# AMENDED

## CORRECTIVE ACTION PLAN

# Fall River Apartments

March 10, 2022  
Amended January 13, 2023

Photo FR22 – Dwelling Unit #212 – Clothes rod exceeds 48".

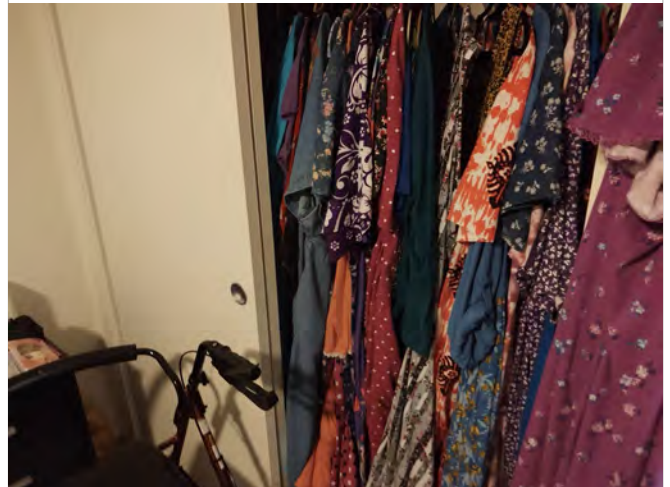
4.25.3 and 4.2.6	Storage - Height	Clothes rods shall be a maximum of 54" from the floor	The top of the clothes rod exceeded 54".	FR #22	The existing clothes rod is to be lowered to not more than 54" above the floor.	The labor to relocate the clothes rod is approximately 1 hour for a labor cost of \$70.00.	\$70	\$70
